CITY OF SEASIDE
BOARD OF ARCHITECTURAL REVIEW

**CITY OF SEASIDE
STAFF REPORT**

Item No.: 6.A.

SUBJECT: **Architectural Review Application No. BAR-16-04: Community Hospital Properties, property owner, and Paul W. Davis, applicant, are requesting changes to the design of a previously approved single-story clinic building and associated site improvements located at 1150 Fremont Boulevard in the Community Commercial (CC) Zoning District. The project is exempt from the California Environmental Quality Act pursuant to Section 15332, Class 32, In-Fill Development Projects.**

Sheet Title:
SITE PLAN

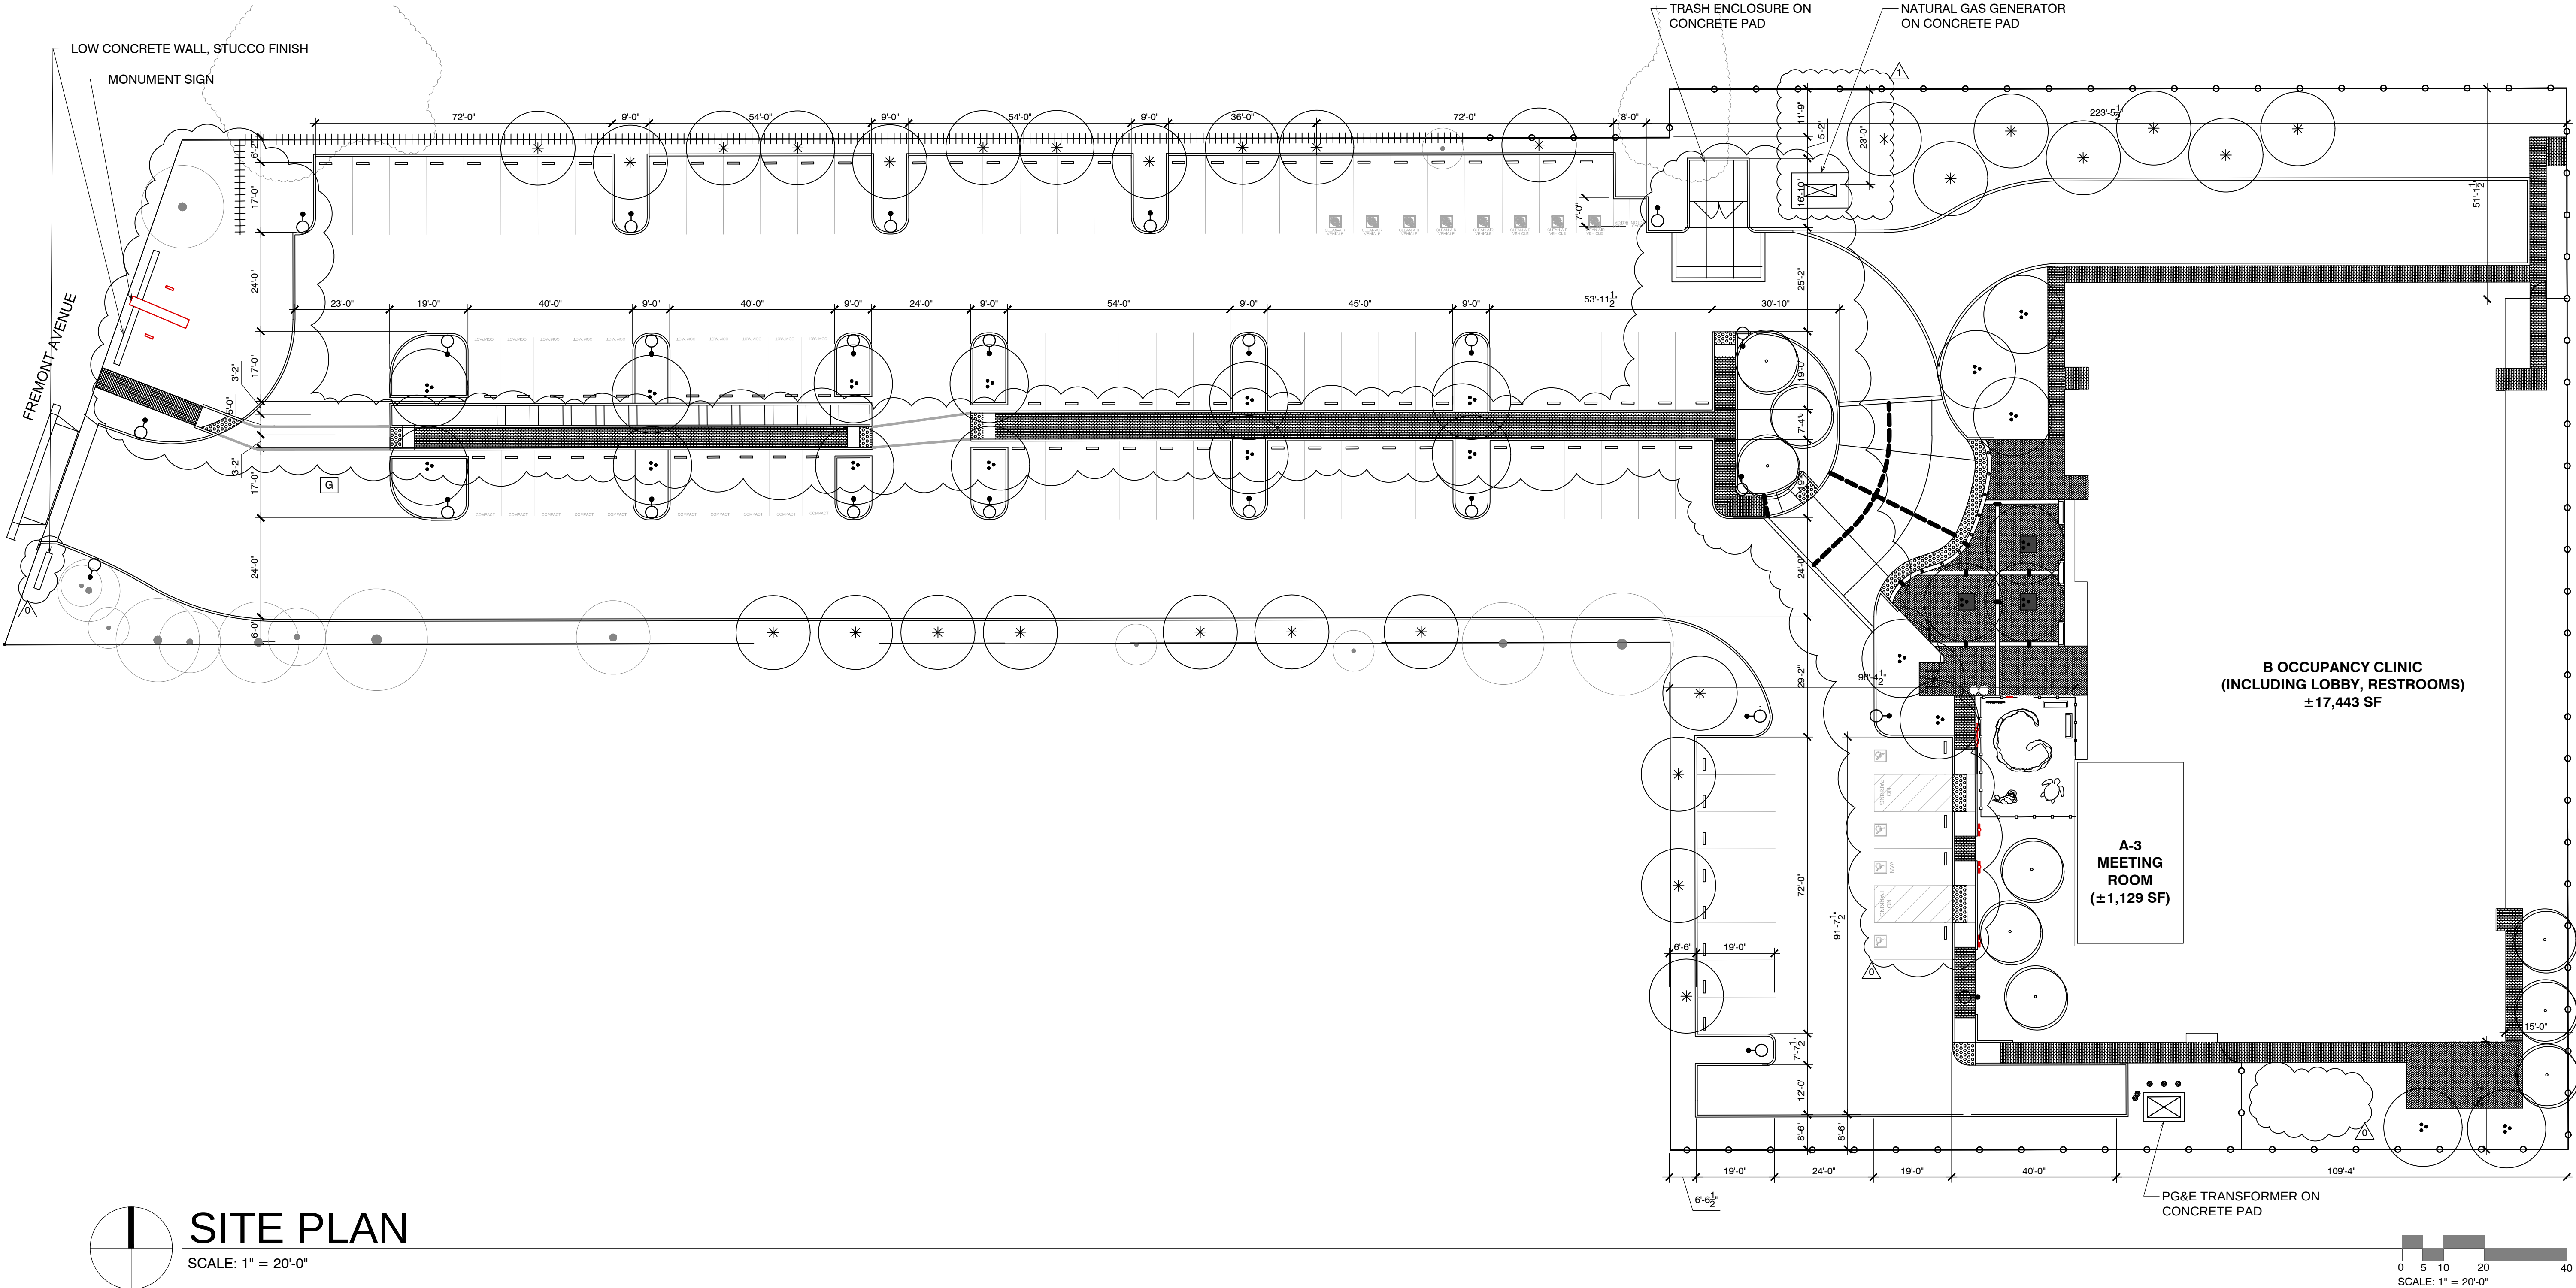
1. Relocation of bio-swales. The new storm drainage system has eliminated the bio-swales located under portions of the site access walk from Fremont Boulevard to the building. Bio-swales are now located in the planter on the inside of the vehicle turn around at the east end of the parking aisle and in the landscaped area along the street front. The swales are approximately 18 inches deep.

2. Modification to proposed walkways. Due to the relocation of the bio-swales, the on-site walkways have been modified as follows:
 - The angled walkway at the front of the site has been eliminated,

- The walkway over the bio-swales within the parking lot have been changed to pervious pavers
3. Modification to landscaping. The landscaping plan proposes to eliminate one plant material (Mexican Lobelia) and replace it with Natal Plum within the modified bio-swales. The landscape architect has confirmed that in accordance with Section 17.34.110.E.4 of the SMC, at least 10 percent (22 percent) of the parking lot will be landscaped.

The trash enclosure and exterior generator have been relocated to the north side of the property to mitigate noise and odor issues to the south. The generator will have a sound attenuation

The proposed changes to the storm drain system will result in a redesign of some bio-swales, a minor realignment of the interior walkway system, and the introduction of one new plant material. The proposed changes will not substantially alter the previously approved project. Staff recommends approval of the proposed changes as submitted.

To address noise and odor issues received by the public and the BAR at the September 16, 2016 and October 7, 2016 BAR meetings, the trash enclosure and exterior generator have been relocated to the north side of the site. Staff recommends approval of the proposed changes as submitted.

Staff recommends approval of the storm drain, bio-swales, walkways, landscaping, trash and generator locations subject to the following findings:

- o The introduction of a revised bio-swale system does not substantially alter the design of the project.
- o The proposed changes to the walkway system maintain the central pathway through the

- o The revised landscaping material is more suitable for areas located within gentle swales and will provide a more durable and hardier plant near potential pedestrian traffic.
- o Locating the trash enclosure near the northerly property line of the parking lot will eliminate potential noise and odors that might be offensive to the neighboring residential property to the south and provide enhanced accessibility for trash pick-up.
- o The new location of the generator will remove a potential noise source on the residential properties to the south and east. The new model would reduce noise levels to less than 60 dB when located 23 feet from the generator which is in compliance with Section 17.30.060.E of the SMC with relationship to the neighboring residential properties.

1 Entry Sign

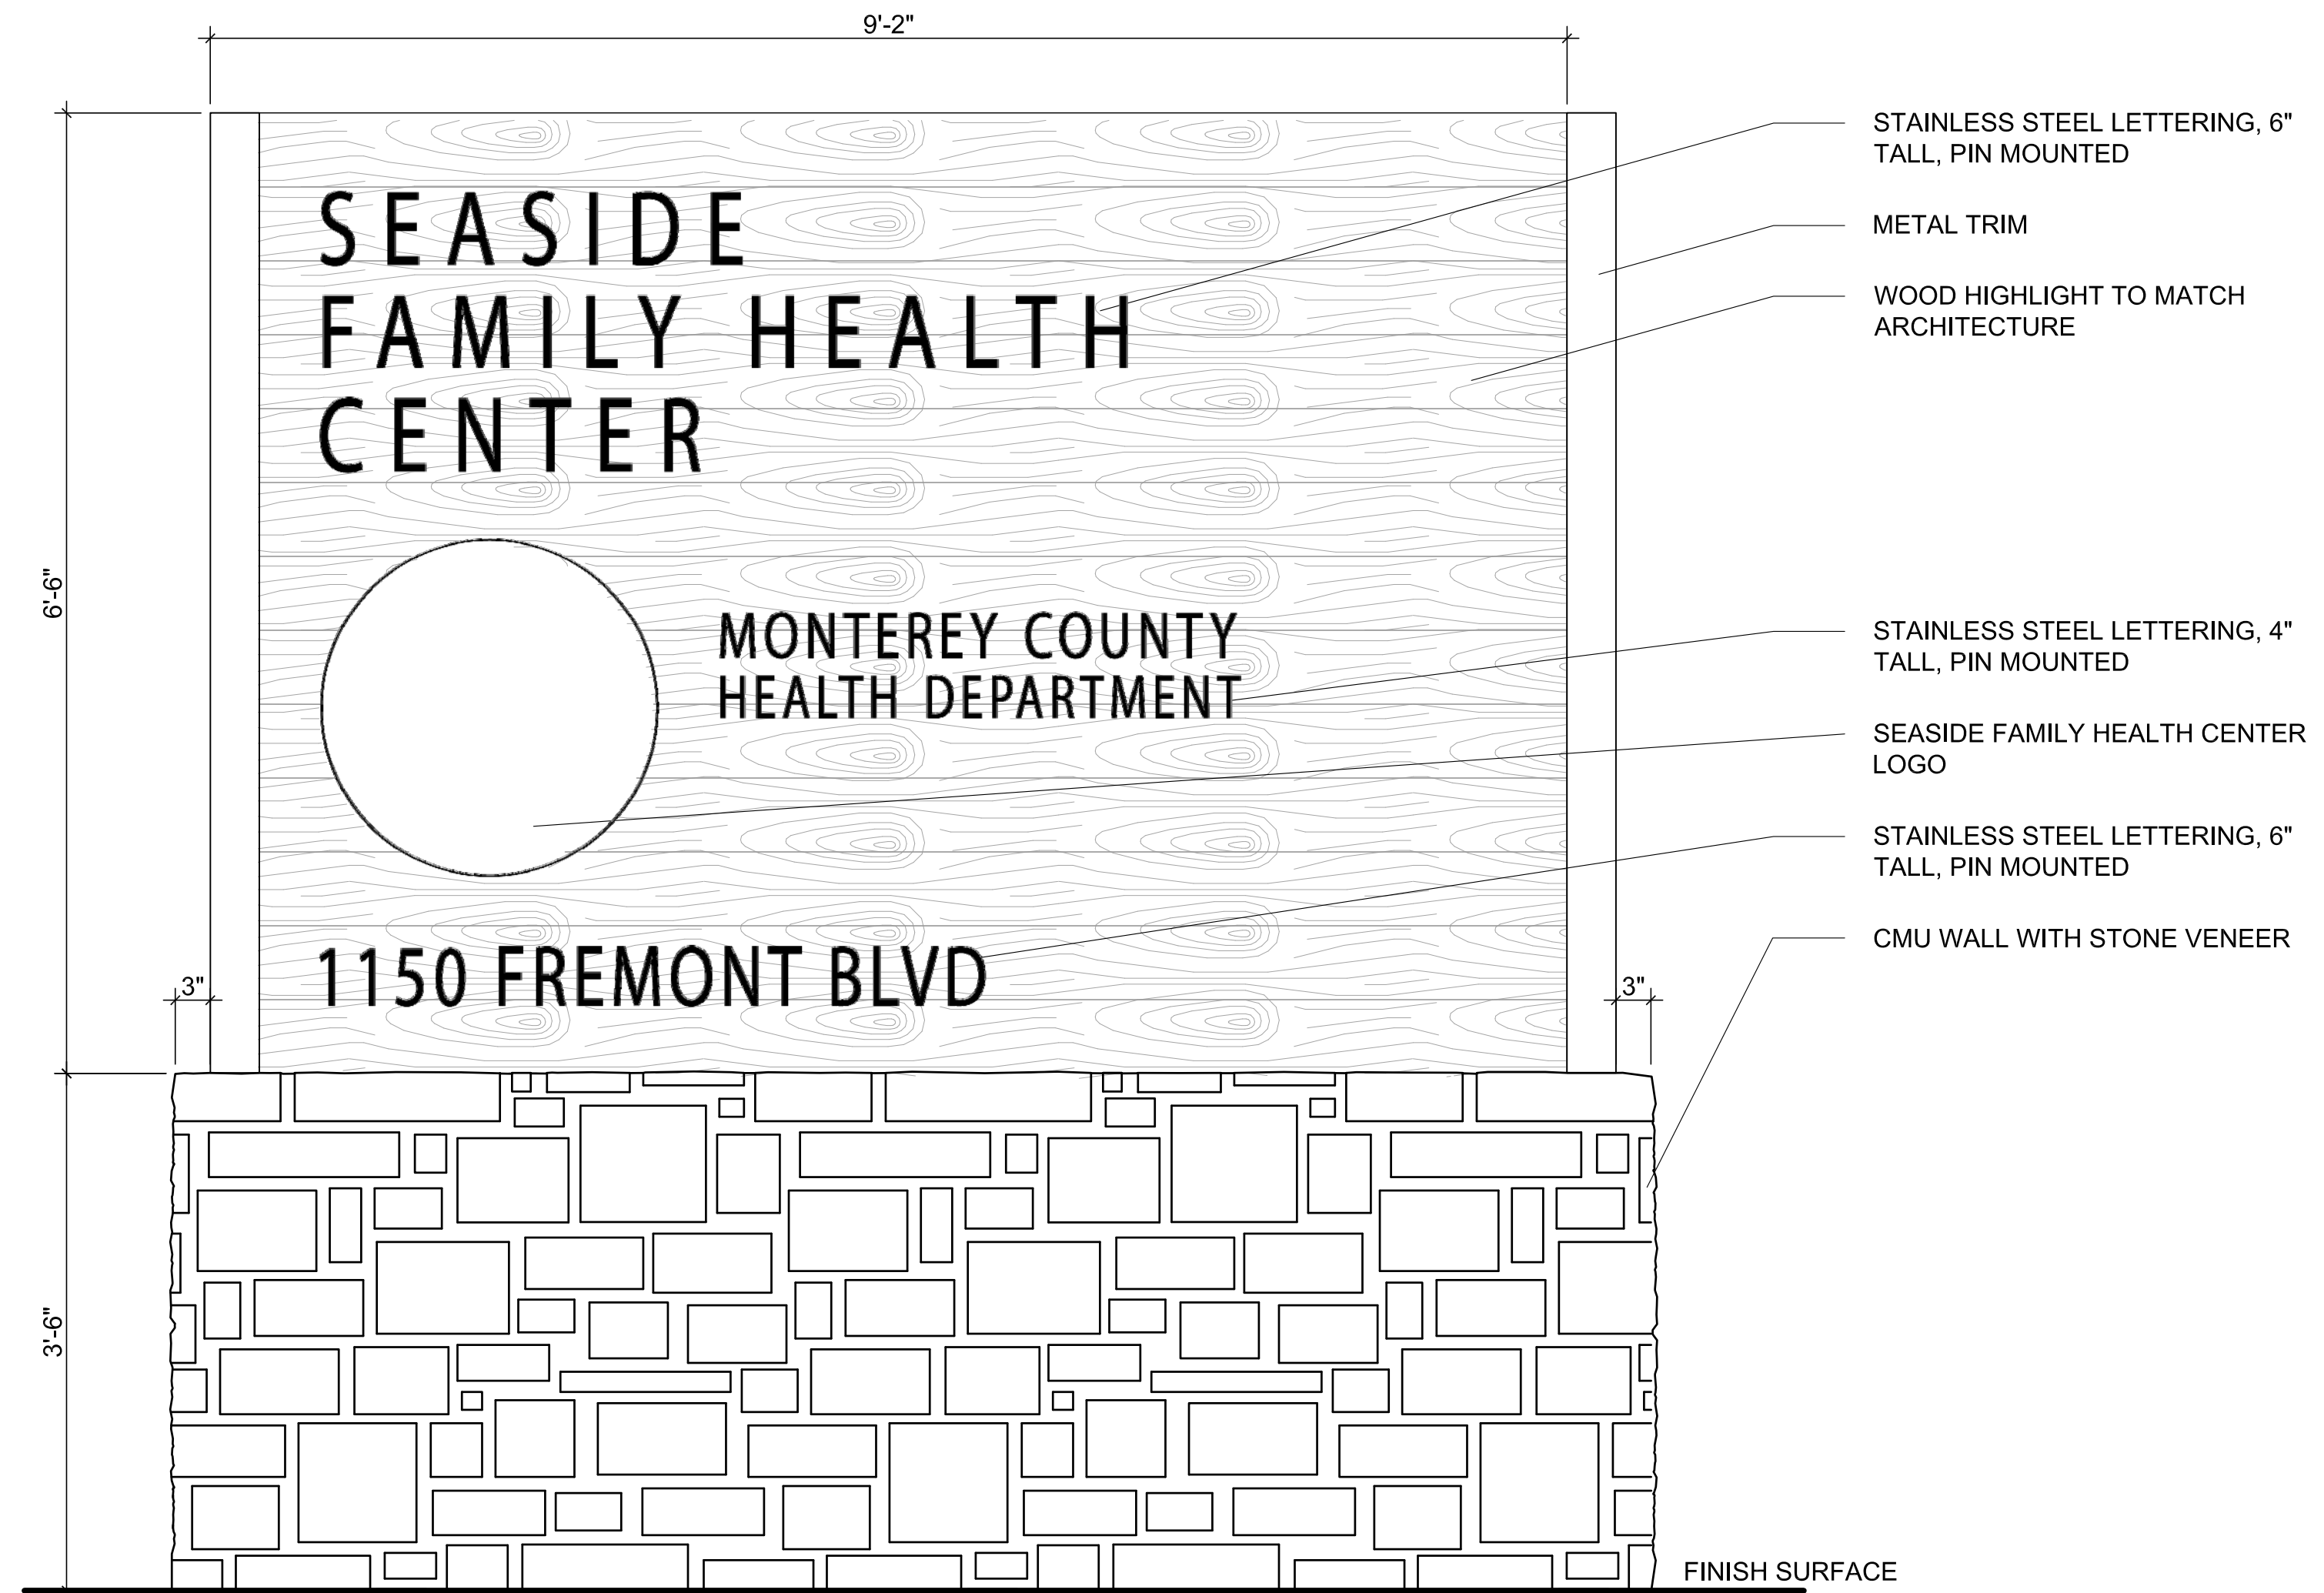
The proposed stone base for the double sided sign and the adjoining low wall is proposed to be replaced with a white stucco finish to match the stucco finish on the building. The applicant states that due to the height of the wall (30 inches) and the height of the adjacent landscaping upon maturity, very little of the stucco would be visible in the near future from the public right-of-way. The applicant has stated that with the low height of the streetscape wall, mature plantings will cover most of the wall façade, irrespective of the finish material used.

Staff finds that a change from a stone veneer to a stucco finish on the sign base and low streetscape wall will diminish the streetscape appearance and will diminish this design feature at the main entry to the site. Staff finds that the stone veneer is a quality material which should remain at this prominent location. Staff recommends denial of the proposed material change from a stone veneer to stucco.

Staff recommends denial of the proposed material change from stone to stucco for the sign base and low streetscape wall subject to the following finding:

- o The use of stone veneer material on the sign base and low streetscape wall was specifically addressed by the BAR as a key design element and will adversely affect the aesthetics of the project. As a key design material, the replacement of the stone veneer with a stucco finish will diminish the streetscape presence of the project.
